## FORM P3: ADMINISTRATIVE DECISIONS AND MINOR AMENDMENTS

Project No. 1005354

16EPC-40059 - Administrative Amendment of Site Development Plan for Building Permit

**Final Sign-off for EPC-approved  
Amended Site Development Plan for Subdivision and Building Permit  
Sawmill Village Redevelopment - Phase 2  
Tract 2-D-1 of ARBOLERA DE VIDA, Unit 2B  
(To subdivide into Tract 2-D-1A and 2-D-1B)**

SDP 5.2 V3

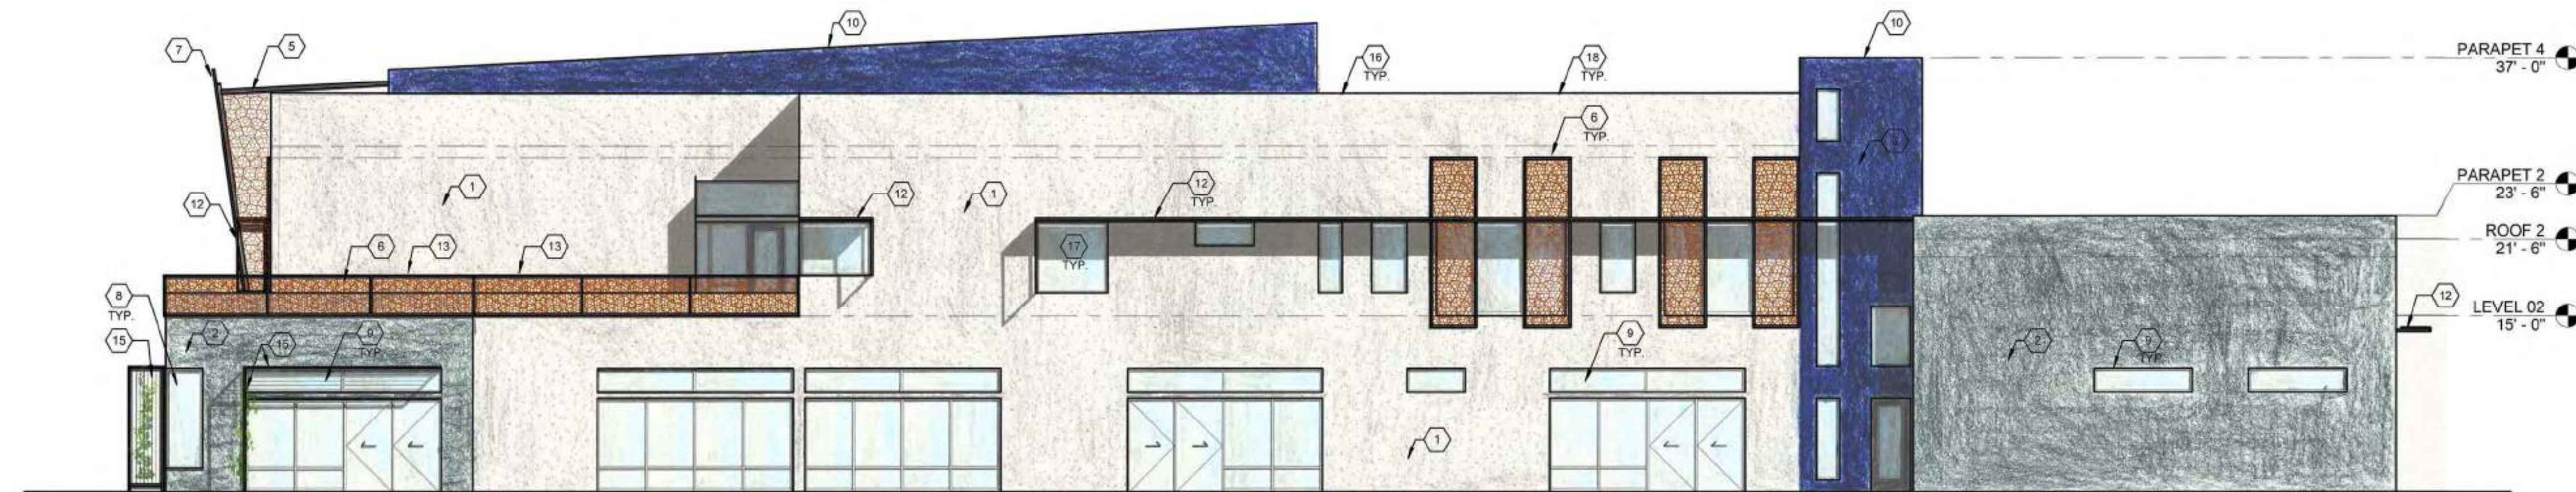
The approved SDP for subdivision and Building Permit and subsequent approval from DRB dated 07/27/2016 (see included in the Drawing Attachment) anticipated a two story 44,000 GSF Public Charter School Building ('Building A2') on track 2-D-1B on SDP. This facility was designed to accommodate total of 450 middle and high school students. However, the School has since then decided to reduce the capacity to total of 350 students, which has resulted in the reduction of overall building area to 38,300 GSF (reduction of 8.7% of total area). Most of this reduction occurs on the 2<sup>nd</sup> floor foot print. There is also a minor reduction (less than 10%) to the 1<sup>st</sup> floor footprint.

Overall, there is less than 10% reduction in Building Volume and Elevations. Other components of approved DRB documents such as finishes, windows, colors, heights, landscape, site work scope, remain the same.
